Authorized Field Change

AFC 01912

Subject: Frame Crossmember Bracket (Gusset) Replacement for 5000i Models Built Between February 28, 2000 to May 9, 2001 with 5 Piece Intermediate Crossmember

Figure 1 Frame Crossmember Bracket Locations Indicated By Arrows

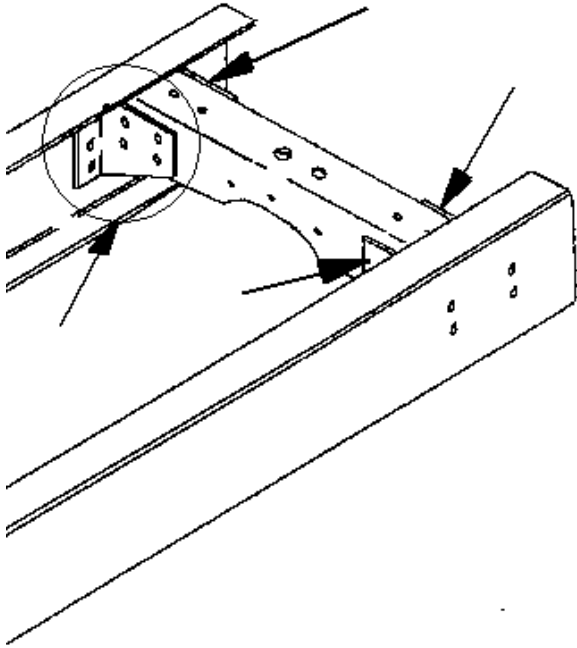
5000i Models built between February 28, 2000 to May 9, 2001 may have frame crossmember brackets, used with 5 piece intermediate and/or front rear suspension crossmembers, made from steel that does not meet specification and press bend marks that could lead to premature failure.

NOTE – Replace each frame crossmember bracket (4) and tighten to specification before proceeding to the next crossmember.

1. Remove four frame crossmember bracket mounting bolts and nuts. Retain for reassembly.
2. Remove two frame crossmember bracket Huckbolts using an approved method.
3. Install a new frame crossmember bracket to the crossmember with the fasteners removed in Step 1. Tighten to 75 to 85 Lbf-ft (102 to 115 Nm).
4. Mount the bracket to the frame with two 5/8 inch bolts and nuts provided in the kit. Tighten to 160 to 175 Lbf-ft (217 to 237 Nm).
5. Repeat Steps 1 to 4 for the remaining three bracket locations on the crossmember.
6. Continue to the next 5 piece intermediate and/or front rear suspension crossmember until all 5 piece intermediate and/or front rear suspension crossmembers have been repaired.
